Title - Sujet CCGC -SOLAR AIR HEATING WALL SYSTEM	
Solicitation No. - N° de l'invitation EB144-150329/A	Amendment No. - N° modif. 004
Client Reference No. - N° de référence du client EB144-15-0329	Date 2014-09-15
GETS Reference No. - N° de référence de SEAG PW-\$HAL-409-9297	
File No. - N° de dossier HAL-4-73040 (409)	CCC No./N° CCC - FMS No./N° VME
Solicitation Closes - L'invitation prend fin at - à 02:00 PM on - le 2014-09-23	Time Zone Fuseau horaire Atlantic Daylight Saving Time ADT
F.O.B. - F.A.B. Plant-Usine: <input type="checkbox"/> Destination: <input checked="" type="checkbox"/> Other-Autre: <input type="checkbox"/>	
Address Enquiries to: - Adresser toutes questions à: Taylor, Kathie	Buyer Id - Id de l'acheteur hal409
Telephone No. - N° de téléphone (902) 496-5510 ()	FAX No. - N° de FAX (902) 496-5016
Destination - of Goods, Services, and Construction: Destination - des biens, services et construction:

Solicitation Amendment #04

Approximate area = 68.04m.

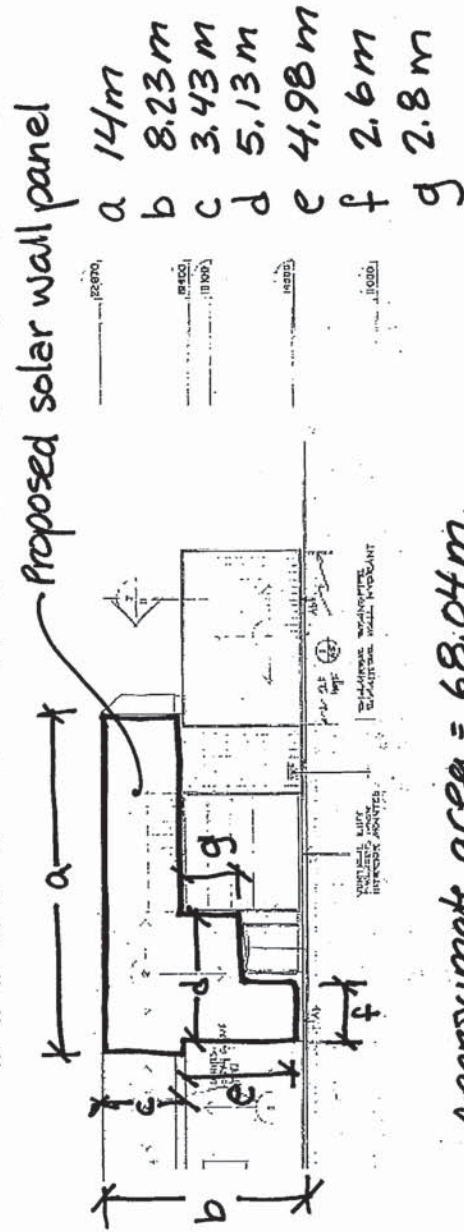
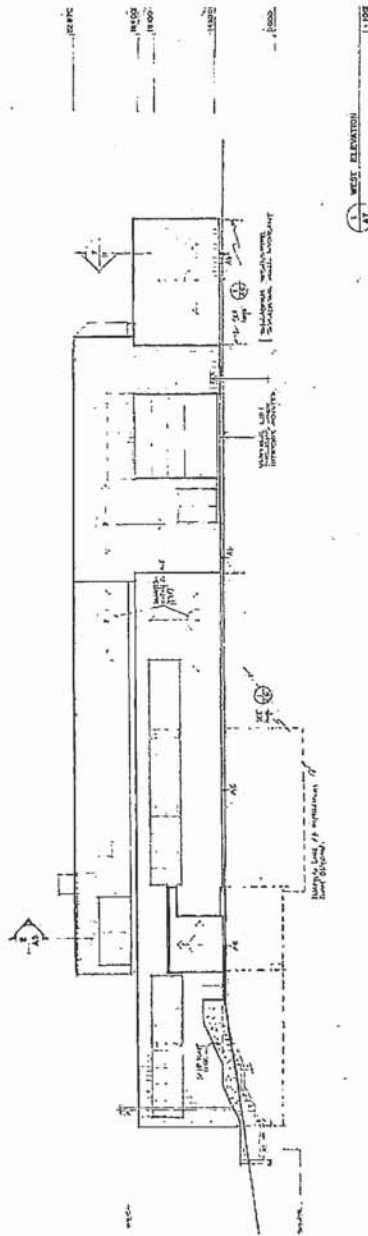
Q3 Can you confirm the placement and wall area for the system to be installed?

Q10 Can we provide a schematic of the wall to provide any structural info and to specify the area of wall intended for application.

A3 See attached sketch, showing suggested approximate location. Exact dimensions may vary depending on manufacturer's specifications.

A10 The overall dimensions of the wall are shown on attached sketch and measure approximately 68 sq m.

PWSSC, JMM, Sept 2014 CCGC Solar Wall

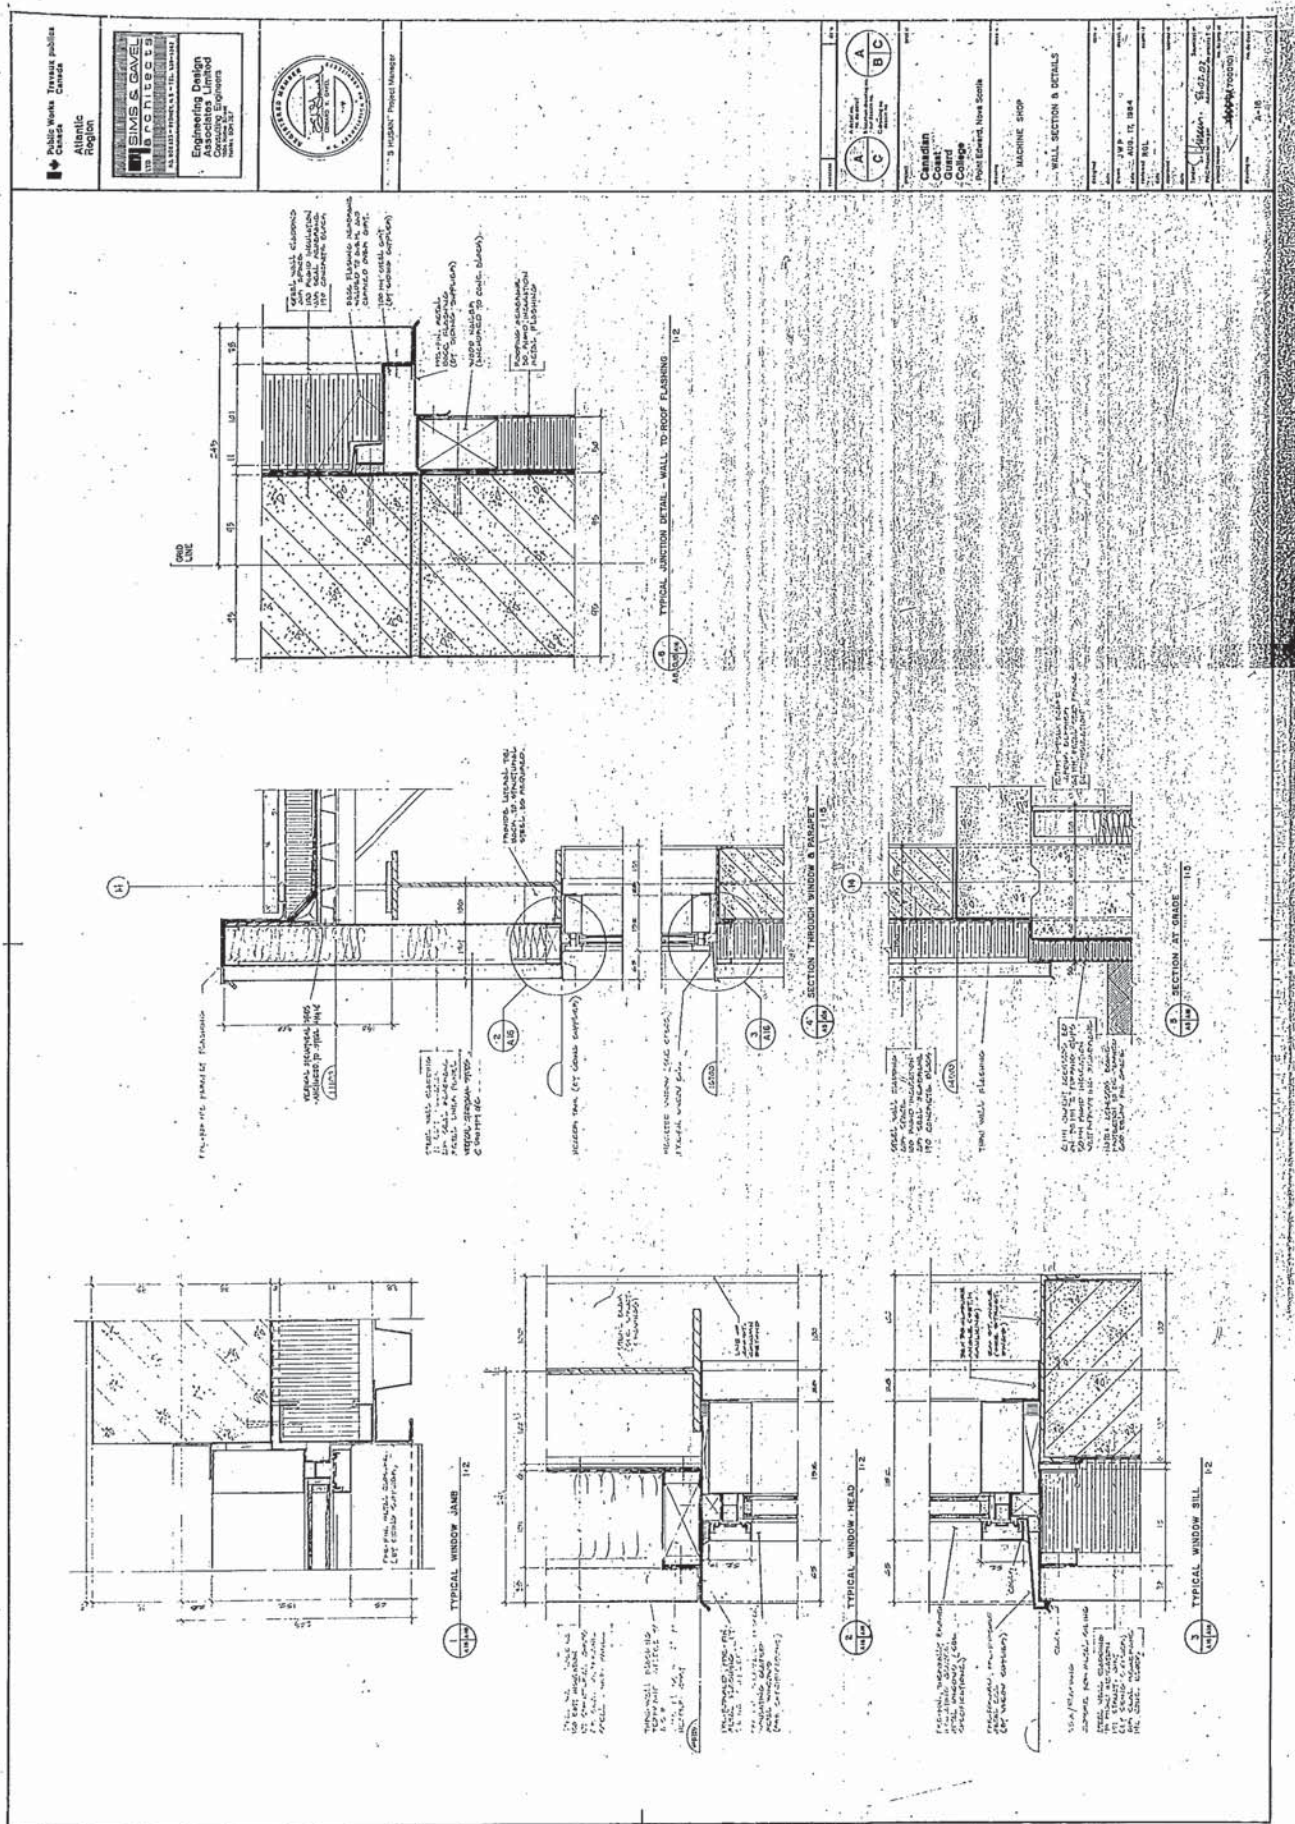
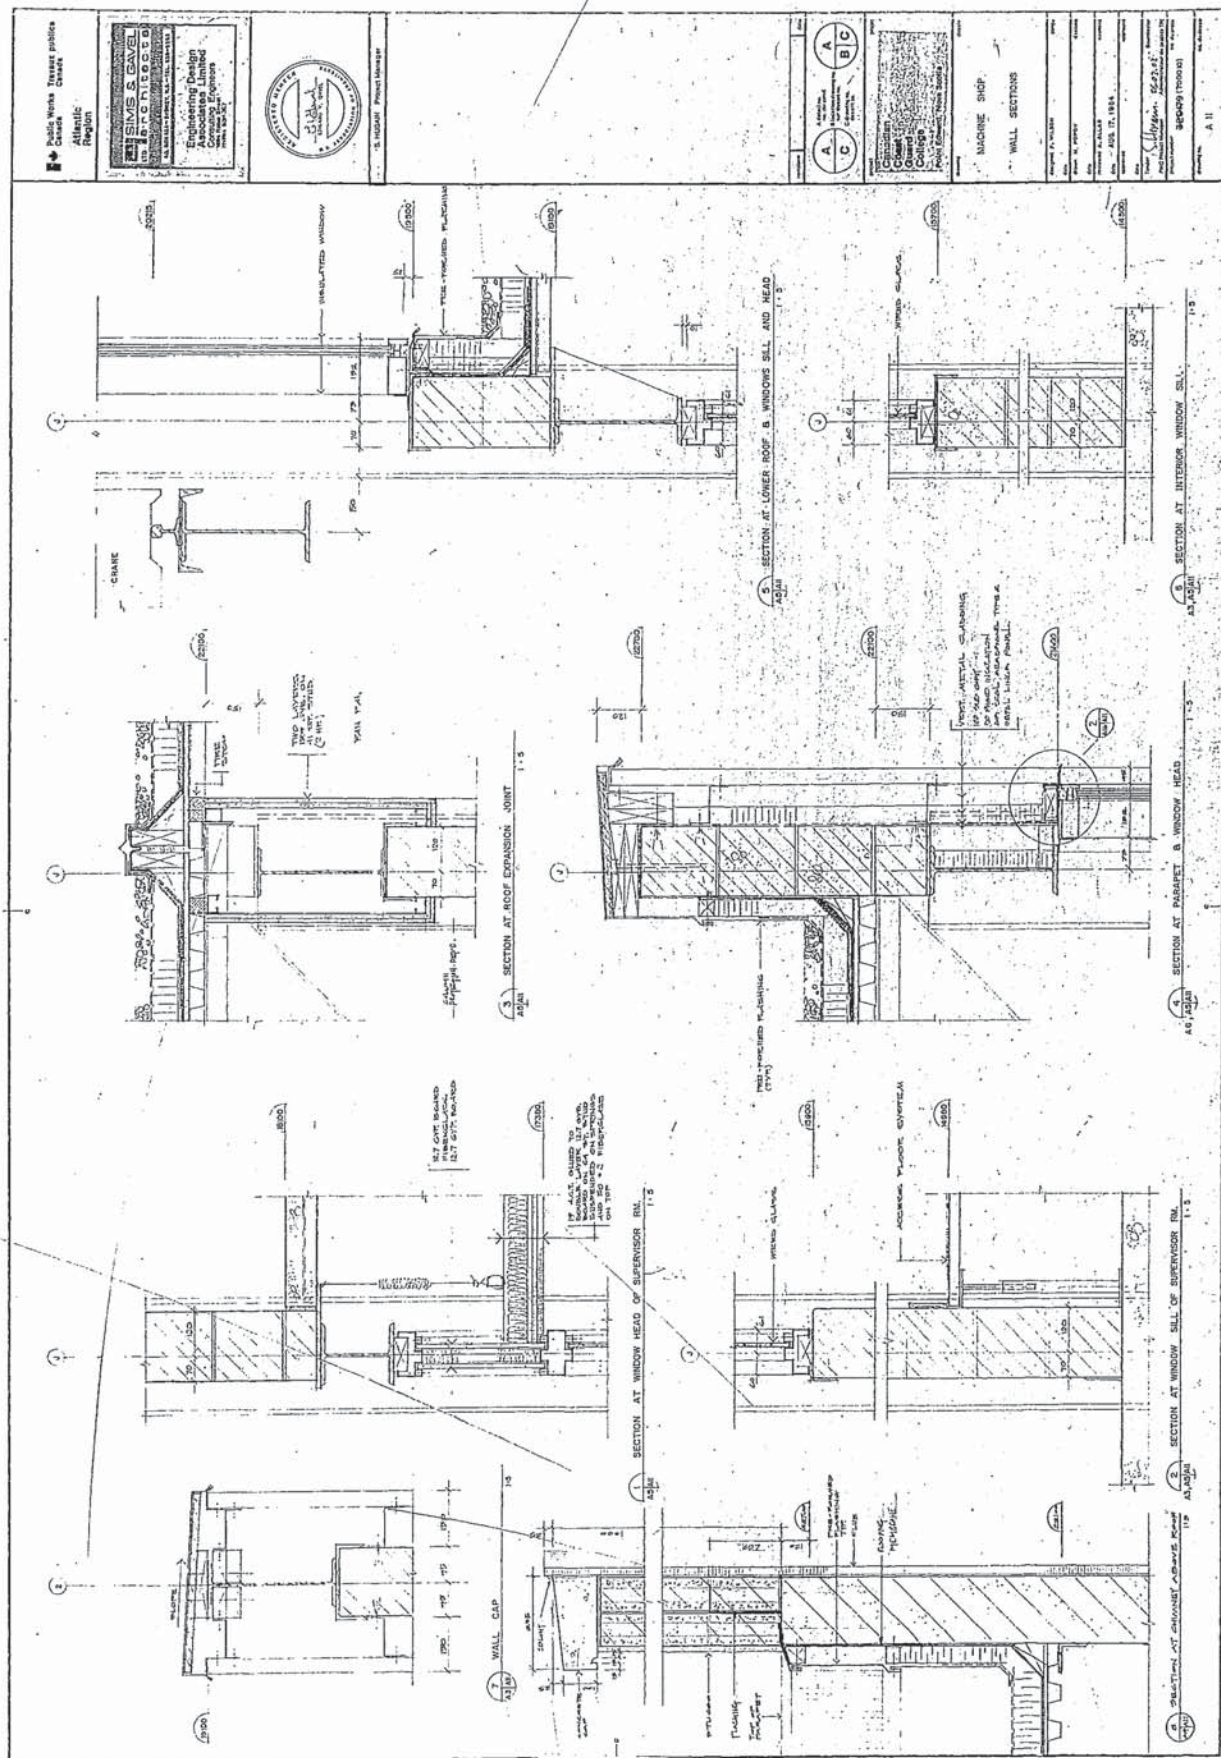
Q4 Please provide a copy of the existing or new wall elevation and wall detail where the SAH is to be installed.

A4 See attached design drawings dated 1984, and marked up sketch.
